Docket Item # 13  
BAR CASE # 2008-0098

BAR Meeting  
July 9, 2008

**ISSUE:** Alterations

**LOCATION:** 2 Duke Street

Figure 2. Existing and proposed demolition for Duke Street elevation.

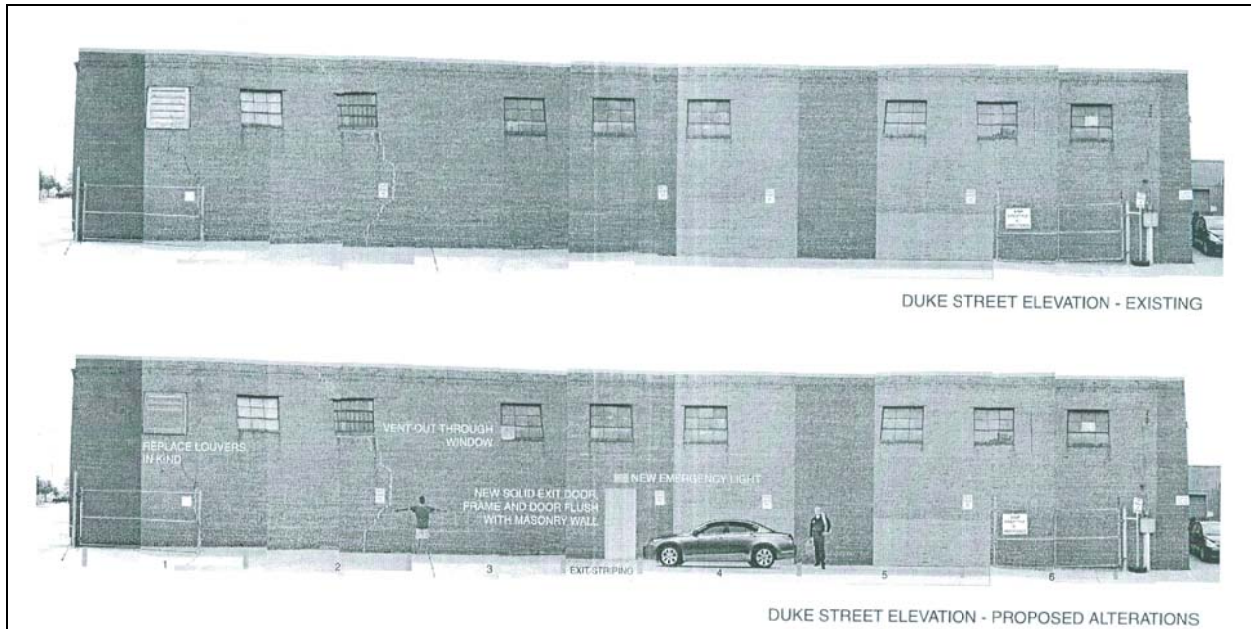
The applicant proposes to demolish five 6' x 6' sections of the roof to accommodate the installation of skylights. The locations of the proposed skylights are generally near the center of the building and will provide day lighting for the interior of the Alexandria Seaport Foundation workshop. The proposed acrylic skylights are domed with the base resting approximately eight inches above the roof. Each one will measure 36 square feet.

Figure 3. Location of five proposed skylights.

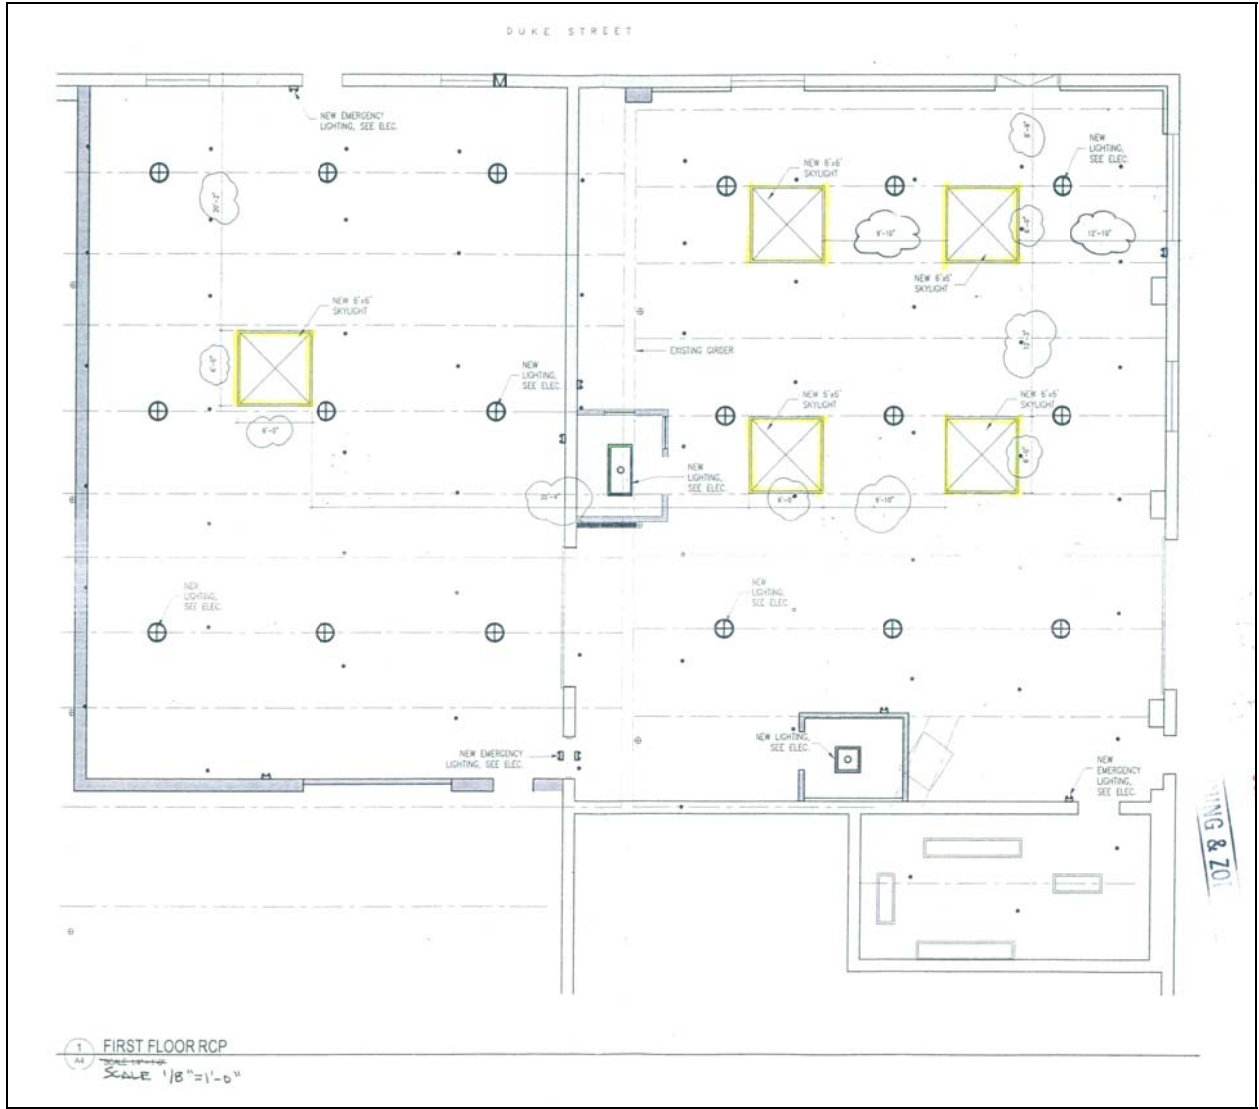
The *Design Guidelines* state that “Skylights should be located on the least visually prominent section of the roof of a structure” and that “low or flat profile glass skylights are preferred...Round or domed acrylic skylights are strongly discouraged.” In addition, the *Guidelines* recommend that to reduce the visibility of the skylight at night, the skylights should have night or integral shades. Staff finds that in this case, the use of an acrylic domed skylight is acceptable. The building’s roof is flat thus minimizing the visibility of the skylights. Although the proposed skylight is dome-shaped it can still be considered low profile, protruding less than one foot total above the roof. Although glass is the preferred material, Staff finds that due to the size of the proposed skylight, the minimal visibility, and the industrial character of the building, that the acrylic is acceptable at 2 Duke Street. The applicant does not propose to equip the

skylights with nightshades but has confirmed that this workshop space will be used predominantly during daytime hours, alleviating concerns regarding light seepage.
